COLERAIN TOWNSHIP BOARD OF ZONING APPEALS

Regular Meeting

Wednesday, May 23, 2018 – 6:30 p.m.

Staff Report:	Board of Zoning Appeals
Case#	BZA2017-19
Variance Request:	Freestanding Sign Variances
Location:	8195 Colerain Ave.
Meeting Date:	May 23, 2018
Prepared by:	Marty Kohler, Senior Planner

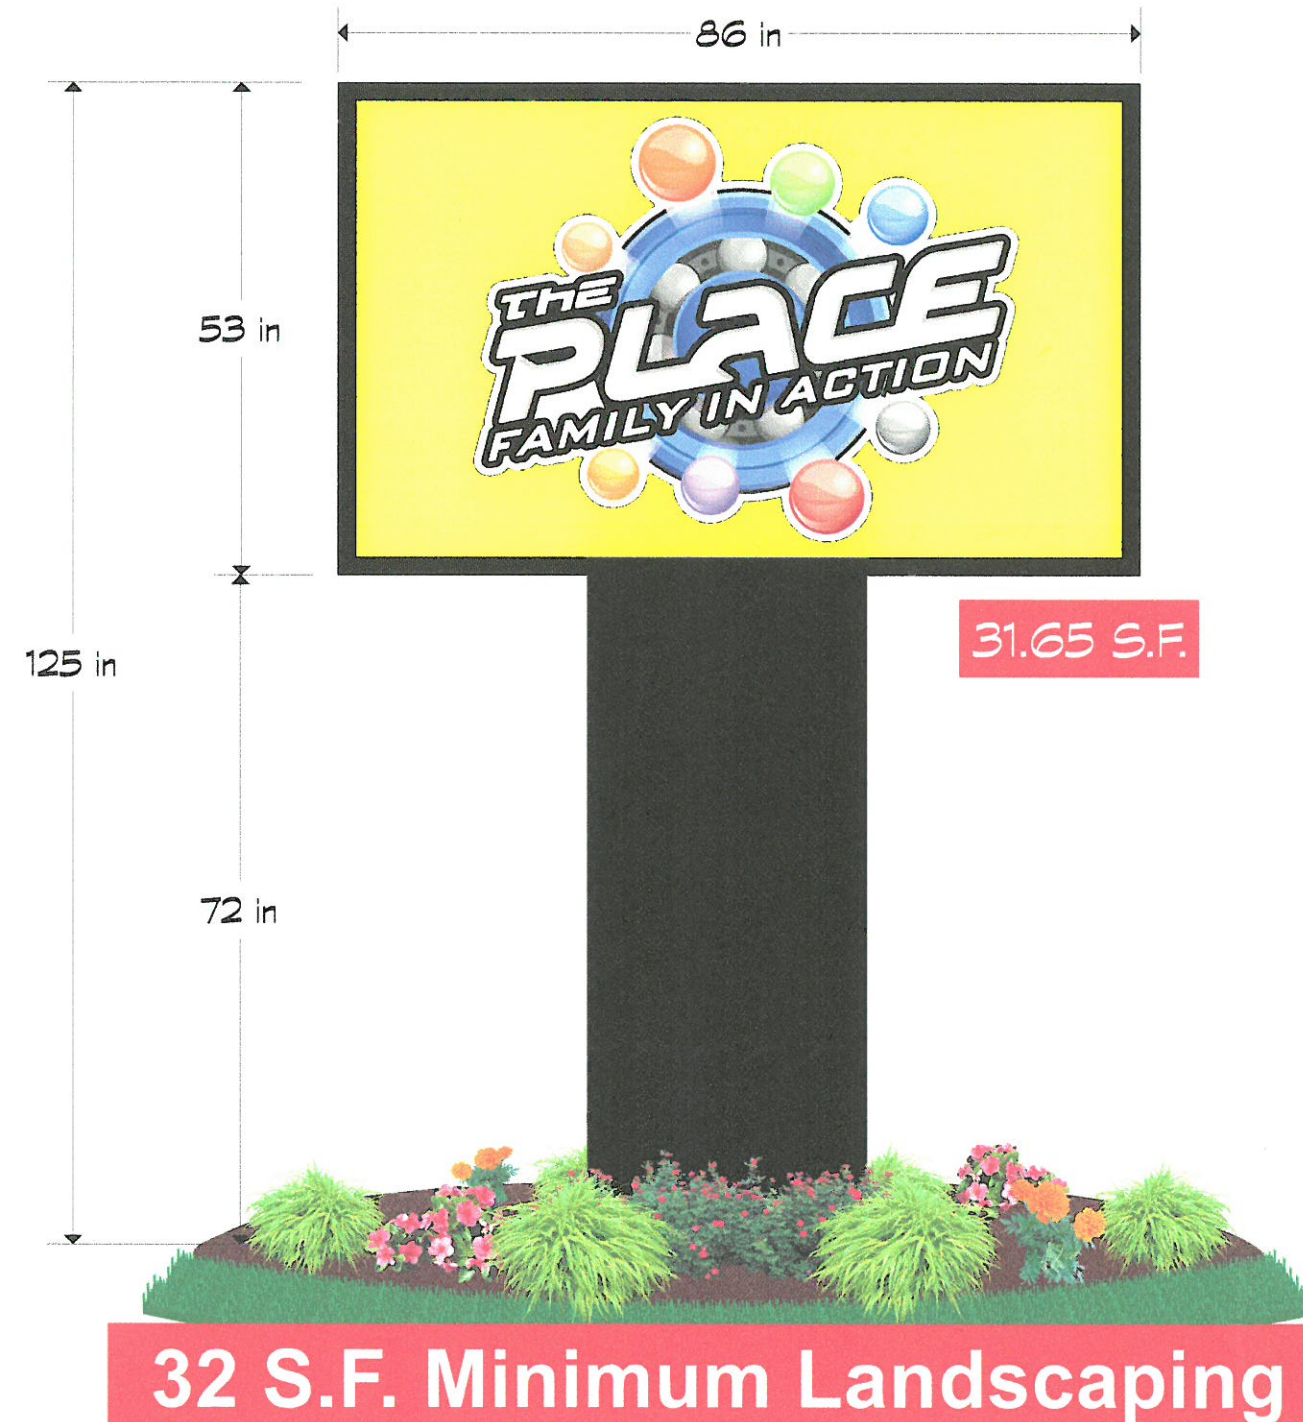
A revised proposal has been received that keeps the electronic sign in the same location on the Thornton's property as the previous proposal. The new proposed sign is 10' 5" tall which is 2 feet less than the previous approval but within the 15 foot maximum height set by the Zoning Resolution. The proposed sign is also 31.6 square feet in size which is 2 square feet smaller than the previous proposal and within the 95 square foot allowance set by the Zoning Resolution.

The revised proposal calls for the removal of the existing non-conforming pylon sign at the entrance drive from W. Galbraith Rd. with a replacement with a sign approximating a "Driveway Sign" as defined by Section 15.8.3(E) of the Zoning Resolution. The proposed driveway sign is 8 square feet in size whereas the maximum allowed is 4 square feet. The proposed height is 4 feet whereas the maximum is 3 feet. The proposed sign would utilize the sign base of the existing pylon sign which places the sign at a setback of four feet whereas the required setback is 10 feet.

The revised proposal includes landscaping equal in size to the area of the proposed sign face which complies with the Zoning Resolution.

1. The sign variances requested are substantial since the zoning resolution encourages the elimination of non-conforming signs and encourages restrictions on the number of signs, Electronically Activated Signs, and billboard signs.

2. The granting of the variances would result in an increase in the overall sign area allowed for the property.
3. The properties in question would likely yield a reasonable return without the variance.

Staff Recommendation: APPROVAL OF ALL SIGN VARIANCES PER THE REVISED REQUEST SUBJECT TO THE FOLLOWING CONDITIONS.

1. That the size of the proposed off-site sign be restricted to 10' 5" in height and 31.6 square feet in size.
2. That the proposed off-site sign and proposed driveway sign be allowed in substitution for a freestanding sign on the driveway owned by The Place on W. Galbraith Road. Only a driveway sign with variances per the revised proposal would be allowed at this location.

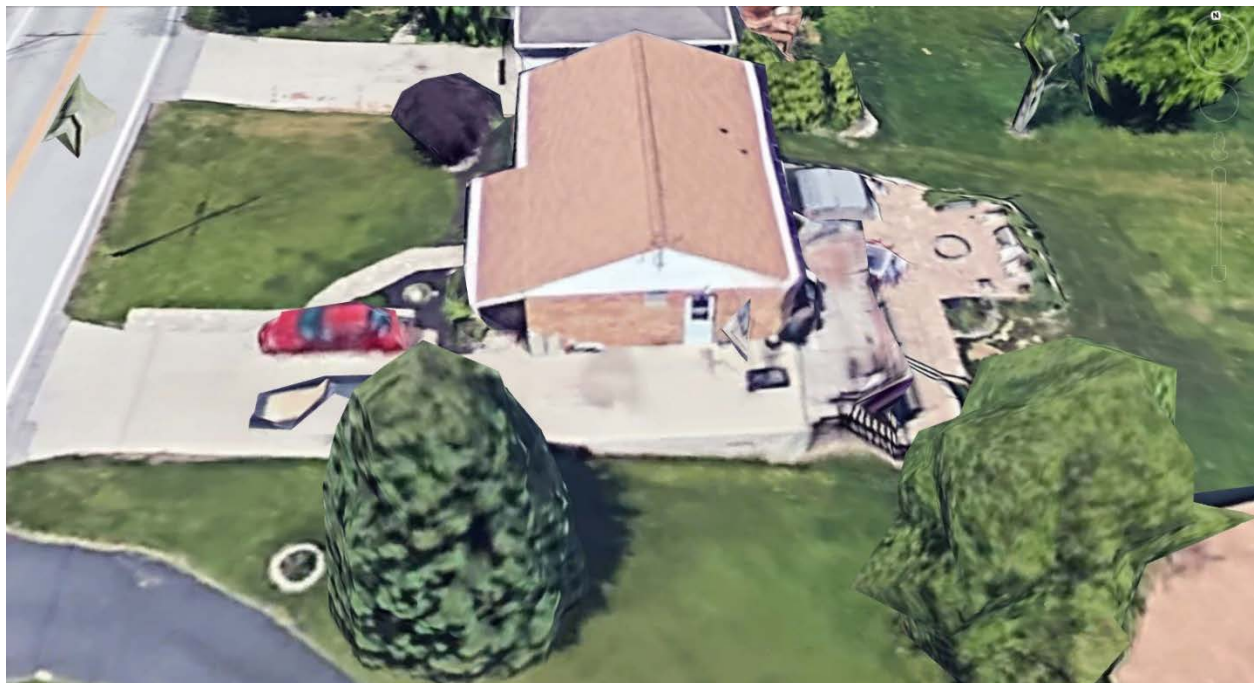
Section 7.3.1 of the Zoning Resolution contains the minimum building setback requirements for residential districts. The property is zoned R-5 Suburban High Residential District which requires a minimum side yard setback of 10 feet on one side with a total of 18 feet on both sides of the house. With the construction of the garage as proposed the total side yard setback would be 10 feet 9 inches (7' 3" short of the minimum) and the larger side yard would be 6 feet 8 inches (3' 4" short of the minimum).

The existing house was constructed well before the current standards were adopted but currently complies with the front, rear and side yard setback requirements. The minimum lot width in the R-5 zone is 70 feet which is about 11 feet wider than the subject property.

The applicant does have the option of demolishing the current side yard parking pad and rear raised deck for the continuation of the driveway down the slope to a rear yard detached garage that would need to be only 5 feet from the side property line. This option may impact the septic system and would also require the construction of a stairway to access the side door to the house.

Staff Recommendation: APPROVAL OF THE VARIANCE REQUEST.
